Access Compliance Report

Public Rights-of-Way

Intersection ID: 45757	Main Street: MOSS_GLEN_CT	Cross Street: GRANDEUR_RD	Location: SE
ADA ID: 7332B8800327	Ramp Type: PerpDiag	Initial Pass/Fail: Fail	Overall Compliance: No
Severity Score: 21.25			
Codes/Mitigation Info/Possible Solution		Field Measurements/Component Compliance

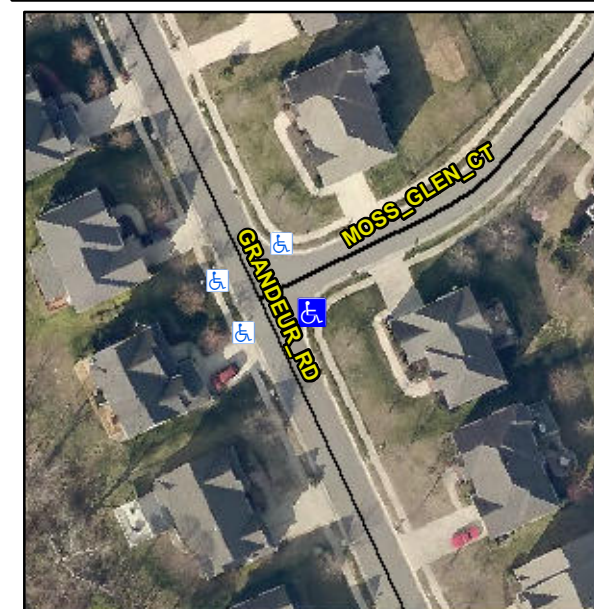
Not Found, R304.5.1, R304.2.2

Compliance	Description	Data	Compliance	Description	Data
N/A	Ramp Length (in)	49.0	No	Ramp Slope (%)	10.5
No	Ramp Width (in)	38.0	Yes	Ramp XSlope (%)	0.8
N/A	Flare Type LT	N/A	N/A	Flare Type RT	N/A
N/A	Flare Slope LT (%)	N/A	N/A	Flare Slope RT (%)	N/A
N/A	Flare Traversable LT?	N/A	N/A	Flare Traversable RT?	N/A
N/A	Landing Length (in)	N/A	N/A	DWS Provided?	N/A
N/A	Landing Width (in)	N/A	N/A	DWS Contrast?	N/A
N/A	Landing Slope (%)	N/A	N/A	DWS Length (in)	N/A
N/A	Landing X Slope (%)	N/A	N/A	DWS Full Width?	N/A
N/A	Landing Curb? (Y/N)	N/A	N/A	DWS Offset (in)	N/A
N/A	Shared Landing?	N/A			
N/A	Gutter Ponding?	N/A	N/A	Gutter Slope (%)	N/A
N/A	Gutter Lip Ht (in)	N/A	N/A	Gutter X Slope (%)	N/A
N/A	Painted X Walk1?	No	N/A	Painted X Walk2?	No
	X Walk 1 Direction	To N		X Walk 2 Direction	To W
N/A	X Walk 1 Width (in)	N/A	N/A	X Walk 2 Width (in)	N/A
	X Walk 1 Slope (%)	1.4		X Walk 2 Slope (%)	1.5
	X Walk 1 X Slope (%)	3.0		X Walk 2 X Slope (%)	1.6

Remove & Replace Curb Ramp With Two New Directional Ramps or Equivalent.
